POLICY REPORT
DEVELOPMENT AND BUILDING

TO: Vancouver City Council
FROM: General Manager of Planning and Development Services
SUBJECT: CD-1 Rezoning: 6010-6050 Oak Street

Figure 1: Perspective Studies

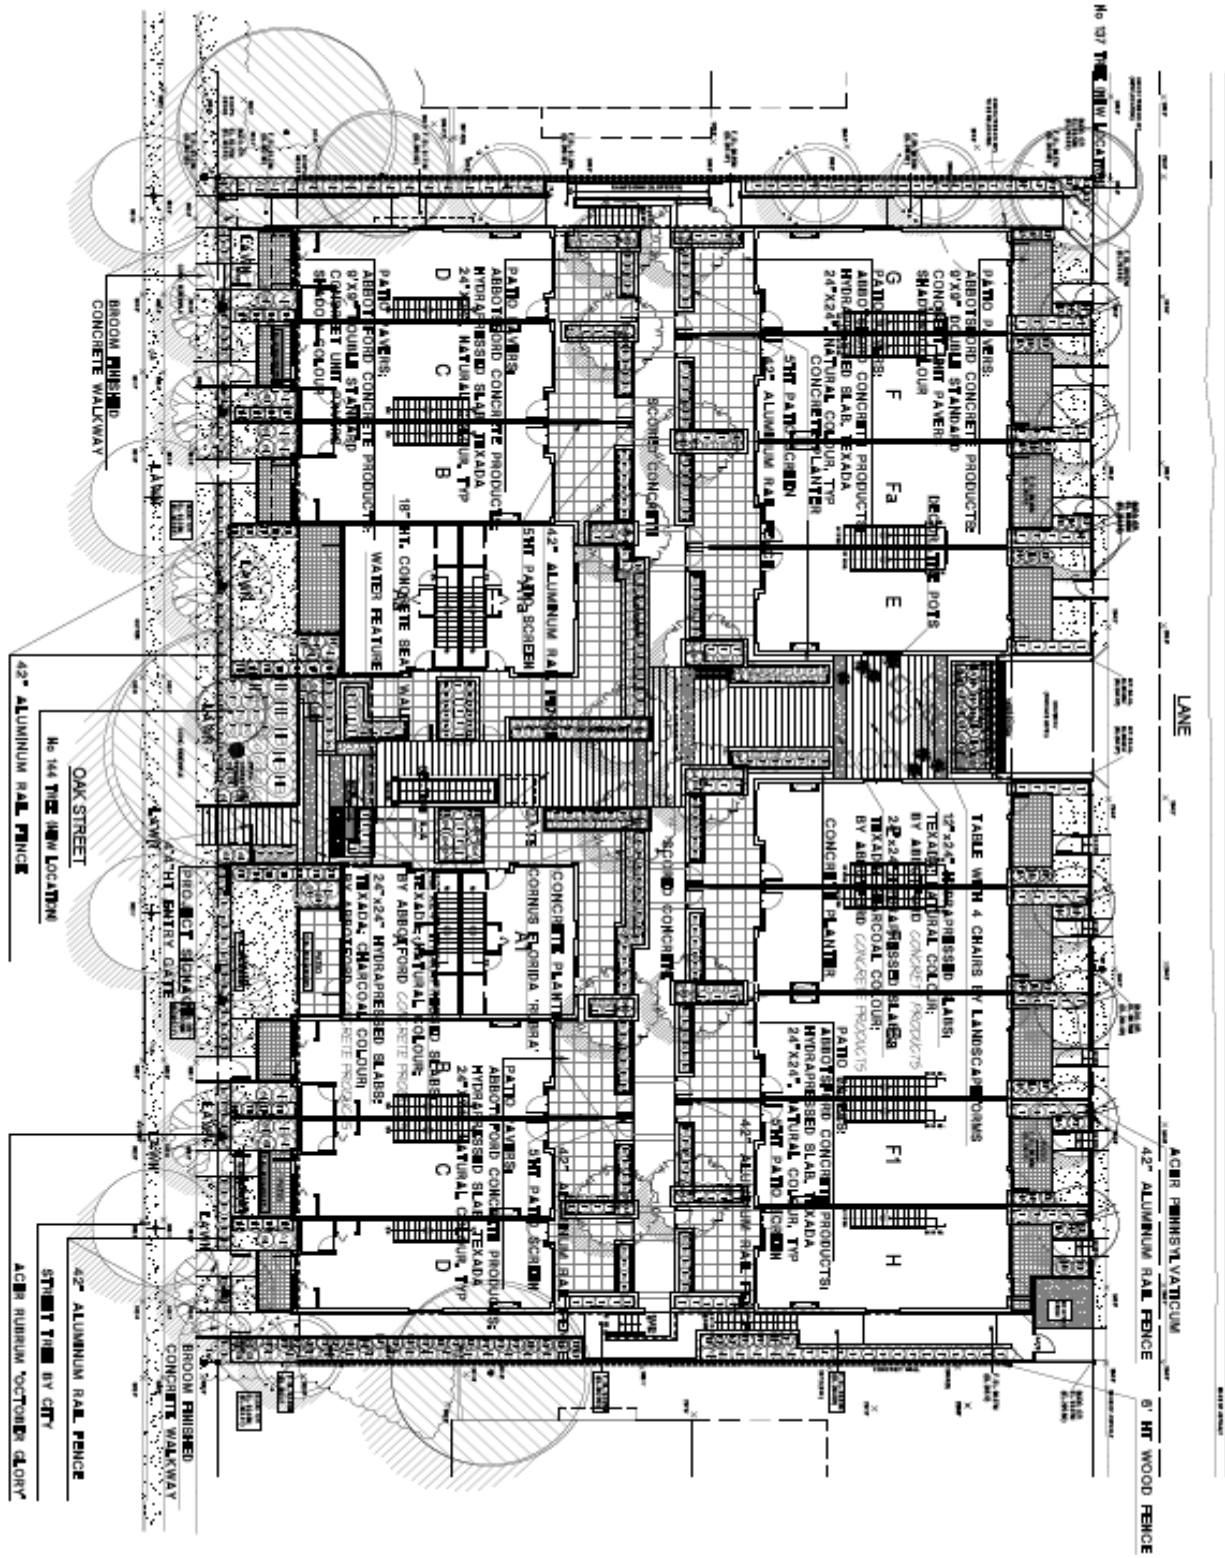
- Is the proposed streetscape design including tree retention successful in incorporating the proposed height into this context?
- Are the different edge conditions well resolved considering the proposed landscape design, setbacks, lane entries, side yards and parkade structure?
- Is the scale and overlook to nearby houses appropriately handled?
- Is the landscape design sufficient in terms of providing a staggered wall/fence buffer along busy Oak Street?

The Panel supported the form and density and thought the proposal was well resolved and was a good approach with the addition of the rental units off the lane. The Panel supported the height; however, one Panel member suggested creating another step in the façade or reducing the mass, as the height is not typical of the area.

Figure 2: Site Plan

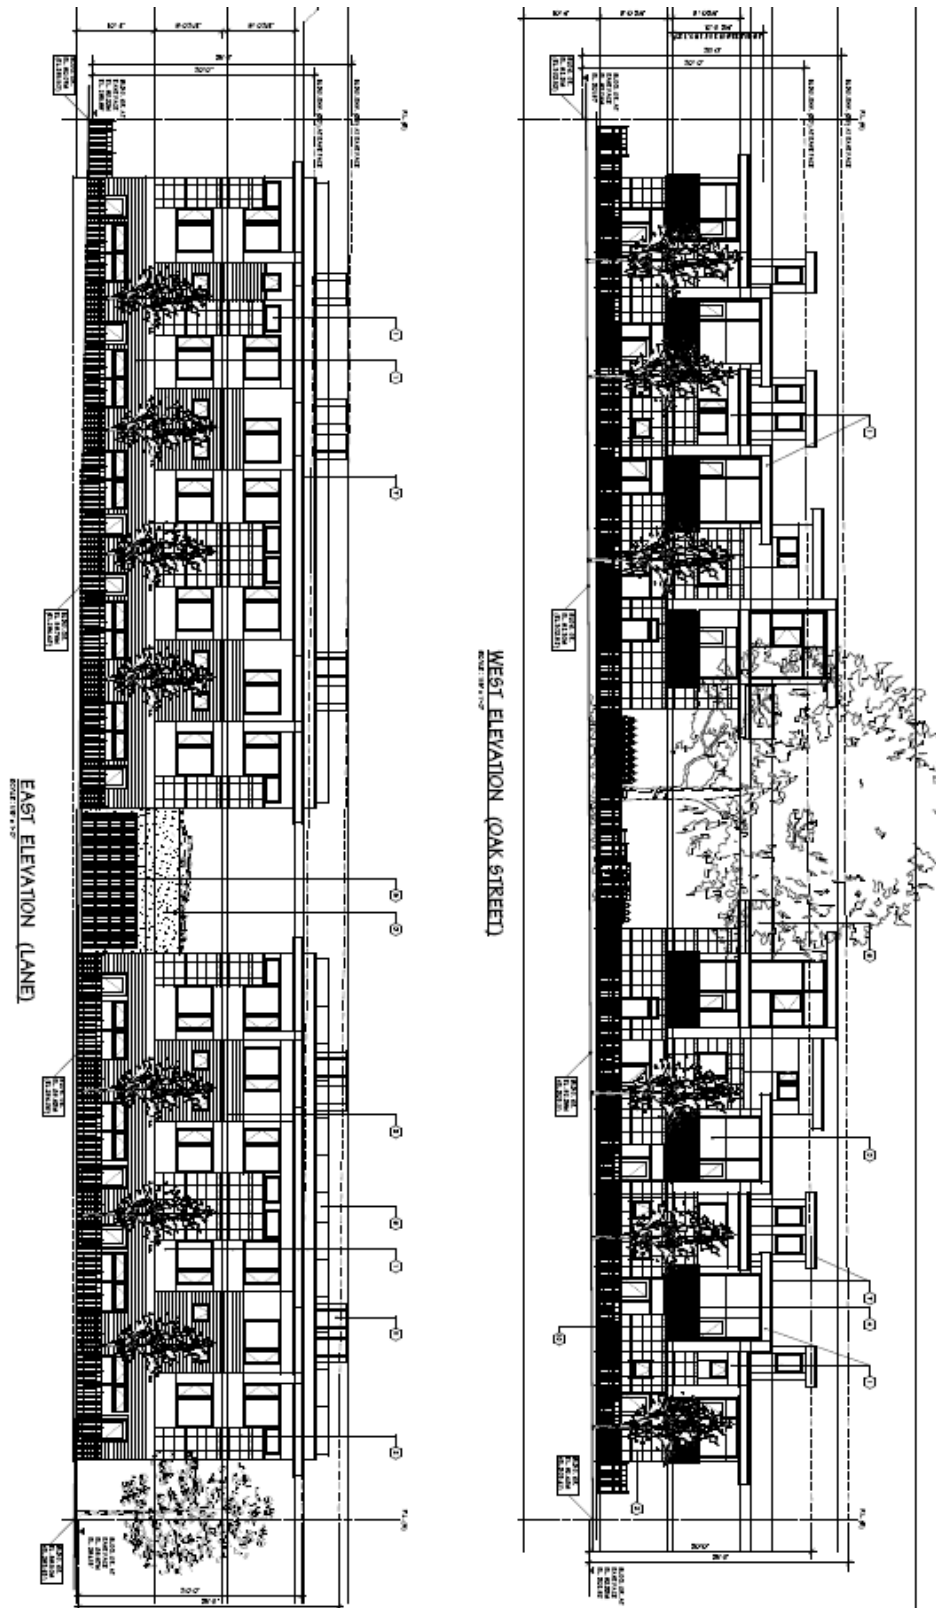
Several Panel members thought the lane expression seemed to have lost some of the strength in the design and should improve. The Panel thought the same amount of care should be taken on the lane as with the front expression and that it should transition better to the neighbours across the lane.

Considering there is a lot of noise on Oak Street, one Panel member thought more should be done at the entry with the water feature and suggested it be moved further

1. Provision of a front setback to the main floor of the building of at least 4.8 m (15.75 feet) and more substantial landscaping between Oak Street and the residential units;

Note to Applicant: Intent is to provide a more substantial buffer to this arterial road way, and allow more substantial planting including additional trees, given the narrow boulevard and sidewalk on this part of Oak Street. If floor area is relocated, it should be sited away from nearby neighbours. The general articulation of the Oak Street façade should be maintained.
2. Design development to continue the built features and expression of the Oak Street and courtyard sides of the building to the other sides of the building, especially the lane;
